Access Compliance Report

Public Rights-of-Way

(Curb Ramps)

Intersection ID: 10671	Main Street: PLYMOUTH_AV	Cross Street: GRIMES_ST	Location: S
ADA ID: F7F012209E04	Ramp Type: Perp	Initial Pass/Fail: Fail	Overall Compliance: No
Severity Score: 8.75			
Codes/Mitigation Info/Possible Solution		Field Measurements/Component Compliance

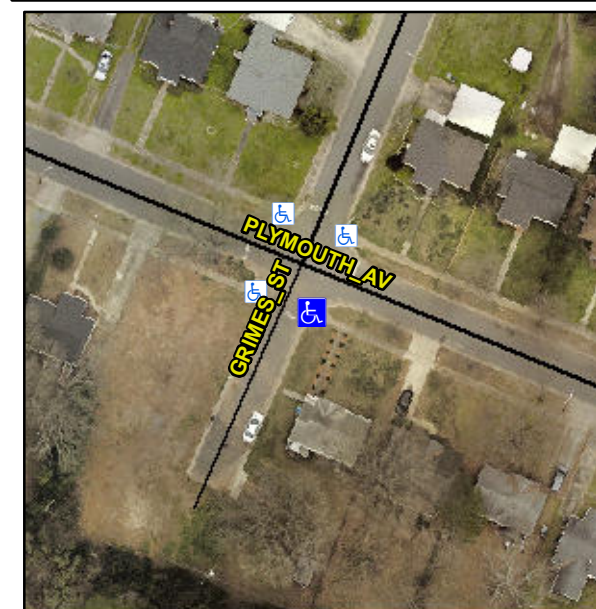
Not Found, R304.5.1

Compliance	Description	Data	Compliance	Description	Data
N/A	Ramp Length (in)	73.5	Yes	Ramp Slope (%)	6.6
No	Ramp Width (in)	40.0	Yes	Ramp XSlope (%)	1.4
N/A	Flare Type LT	N/A	N/A	Flare Type RT	N/A
N/A	Flare Slope LT (%)	N/A	N/A	Flare Slope RT (%)	N/A
N/A	Flare Traversable LT?	N/A	N/A	Flare Traversable RT?	N/A
N/A	Landing Length (in)	N/A	N/A	DWS Provided?	N/A
N/A	Landing Width (in)	N/A	N/A	DWS Contrast?	N/A
N/A	Landing Slope (%)	N/A	N/A	DWS Length (in)	N/A
N/A	Landing X Slope (%)	N/A	N/A	DWS Full Width?	N/A
N/A	Landing Curb? (Y/N)	N/A	N/A	DWS Offset (in)	N/A
N/A	Shared Landing?	N/A			
N/A	Gutter Ponding?	Yes	N/A	Gutter Slope (%)	N/A
N/A	Gutter Lip Ht (in)	N/A	N/A	Gutter X Slope (%)	N/A
N/A	Painted X Walk1?	No	N/A	Painted X Walk2?	N/A
	X Walk 1 Direction	To NW		X Walk 2 Direction	N/A
N/A	X Walk 1 Width (in)	N/A	N/A	X Walk 2 Width (in)	N/A
	X Walk 1 Slope (%)	6.0		X Walk 2 Slope (%)	N/A
	X Walk 1 X Slope (%)	3.4		X Walk 2 X Slope (%)	N/A

Remove & Replace Entire Ramp.
